Squeaks & Rattles – Noise from Wiper Box
& Harness – Install Foam Pad

MODEL 1995 MY
Sedan Range
VIN 720001-ON

ILLUSTRATION 1

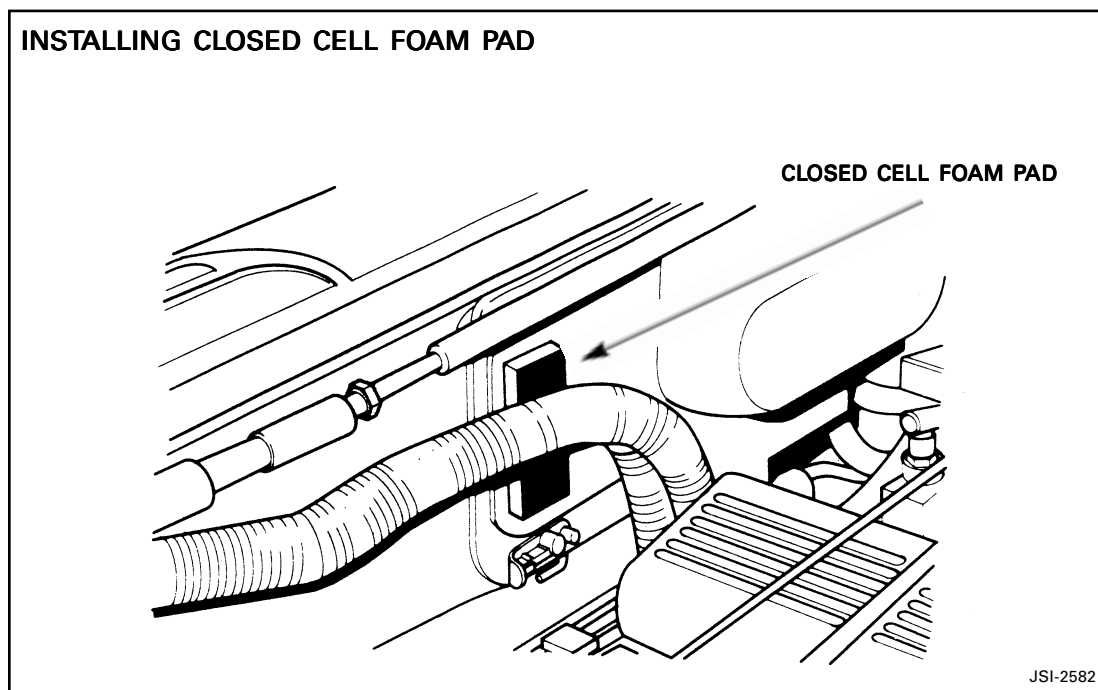
Some 1995 MY Sedan Range vehicles from the above VIN may exhibit a noise from the center of the fascia.

The noise may be caused by contact between the fuel injection harness and the front face of the wiper motor box.

Only in case of a customer complaint of noise as described above on a 1995 MY Sedan Range vehicle within the above VIN range, apply a closed cell foam pad to the wiper motor box as shown in Illustration 1.
